Subject: Atascadero - San Luis Obispo 70kV Power Line Reconductoring Project Variance Request #8 for an additional laydown area adjacent to the Atascadero Substation

Environmental Variance Request Form

Atascadero - San Luis Obispo 70kV Power Line Reconducting Project

Detail Map

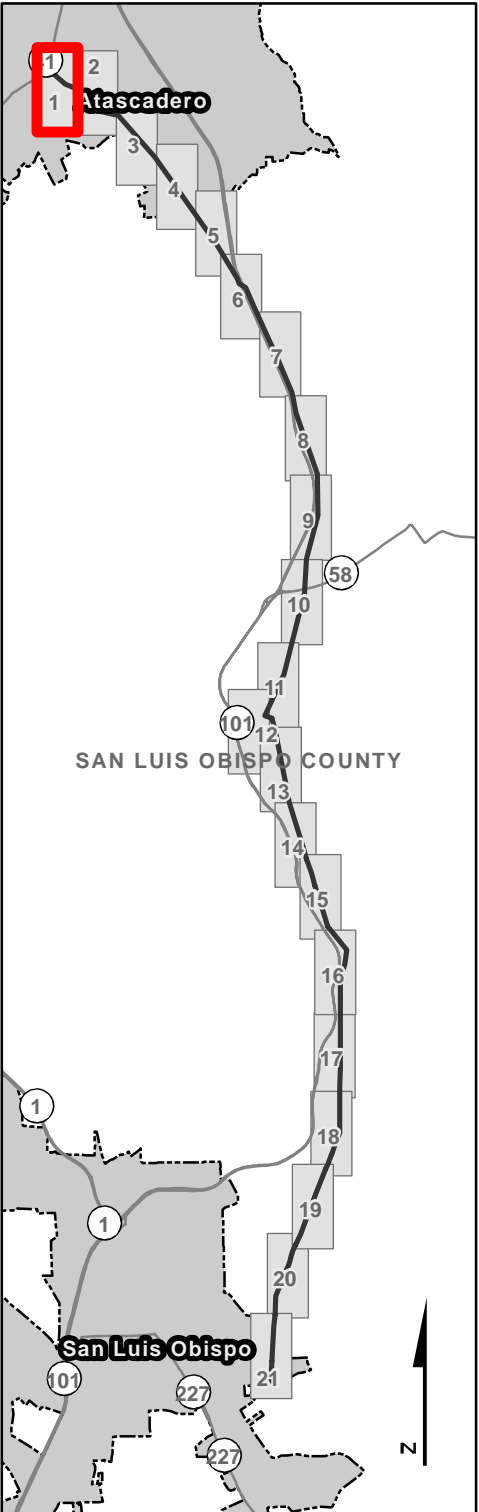
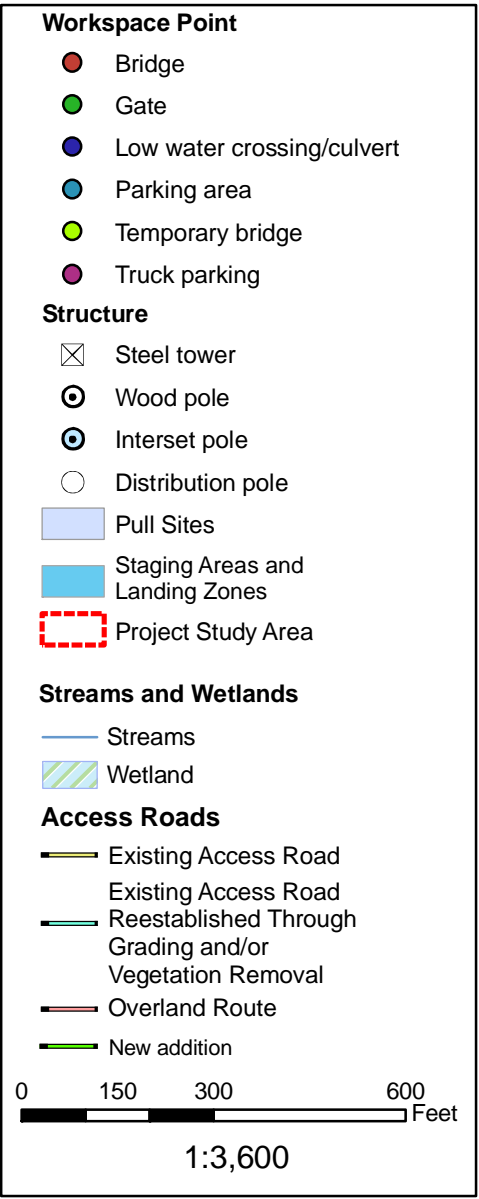
Variance Summary Description: PG&E has identified the area adjacent to the Atascadero Substation for use as a laydown area.

Describe variance in detail: The area to the south of the Atascadero Substation is composed of decomposed granite and gravel. It is approximately 12,200 square feet and is owned by PG&E. The PG&E wood pole crew has identified the existing gravel and DG area for laydown of poles and associated hardware. Most of the area has been previously approved for use as a pull and tension site (see attached detail map). The laydown area would be utilized to temporarily stage poles along with associated hardware. Poles and hardware currently stored at the Templeton yard will be periodically delivered to the site by truck. Hardware will be framed on the poles and will be transported from the laydown area to specific pole locations after holes are excavated. After replacement pole locations within the City limits have been prepared and a line outage clearance has been authorized, the framed poles will be removed from the laydown area and installed. Framing would be completed with power and hand tools and would be performed no differently than if it were being done at the individual pole sites, but would minimize the disturbance around each of those pole sites. Use of the laydown area would reduce the number of round trips required to obtain poles from the Templeton yard.

If no, explain why survey not needed: Site is an existing gravel/DG parking area

If no, explain why survey not needed: Site is an existing gravel/DG parking area

If no, explain why survey not needed: Site is an existing gravel/DG parking area. No ground disturbance is needed.
